Modification Recommended Service Note

P9373B Keysight Streamline Vector Network Analyzer

Serial Numbers: From MY61100288 to MY61100353

Potential lifted front panel overlay

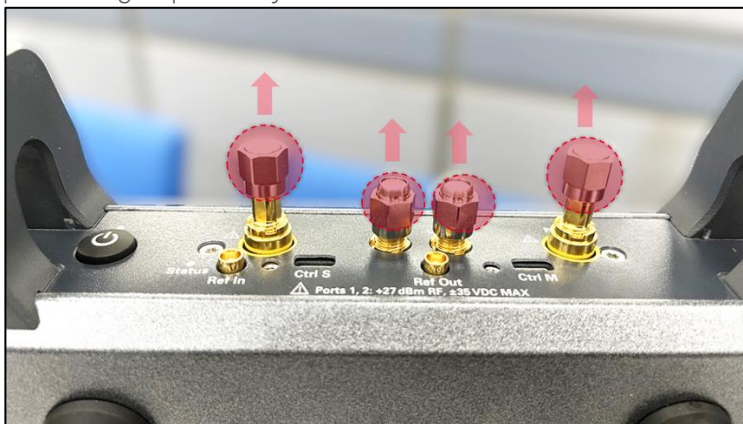
Keysight streamline series vector network analyzer (VNA) of serial number range identified in service note cover page might potentially exhibit the following lifted front panel overlay symptom.

Apart from cosmetic imperfections, the lifted front overlay could have led to non-fully attached *Ctrl S* micro-HDMI cable connector in multi-VNAs setup configuration.

-> Apply this service note only if end users' VNA is exhibiting the following symptom.

Procedure to replace the front panel overlay.

1. Remove the front handles. Detach the 50-ohm termination (LO-In, LO-Out, Port 1 & Port 2) or protecting caps if they are attached to the VNA.

2. Pry open the existing front panel overlay and remove it from front panel.
3. Clean the metal surface thoroughly and ensure it is free of adhesive residue.
4. Affix the new self-adhesive front panel overlay onto the metal surface.
5. Reinstall (reuse) the 50-ohm terminations and port protecting caps accordingly.

6. Reinstall (reuse) the front handles.
